Hi-Fi Products  
**Service Bulletin**

**Model:** STR-313, TA-313

**No.186**

**Subject:** Output Oscillation After  
Replacement of Output AMP

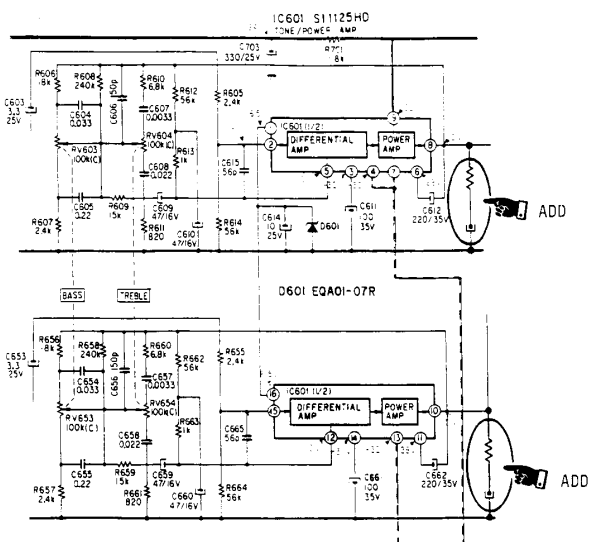
After the replacement of the output amp (SI-1125 or SI-1225), with the replacement kit STK-4133II, oscillation at the output can occur. This is because the specifications for the replacement kit and those of the original amp do not match.

1. Remove the output IC from the board and heatsink.
2. Remove capacitors C661, C662, C612 and C611 from the circuit board (C204, C207, C254 and C257 on the TA-313).
3. Add two capacitors (220pf 50V) to the circuit board that the replacement STK-4133II is mounted on. One cap is to go across pins 1 and 3, the other goes across pins 16 and 18.

4. On the printed circuit side of the Main Amp Board, connect two sets of resistors and capacitors (10 Ohm 1/2W and .033  $\mu$ F 50V). One set between audio output Pin 10 and GND, and the other between Pin 8 and GND. These components can be placed in the locations of the capacitors removed in Step 2.

5. Mount the new IC (and its circuit board) onto the power amp board and heatsink.
6. Modify the length of the black ground wire so that it can reach ground points between capacitor C701, and C702 (C501 and C502 on the TA-313).

**Note:** If the oscillation still occurs, go back to Step 4 and change the values of those capacitors to .056 $\mu$ F 50V.
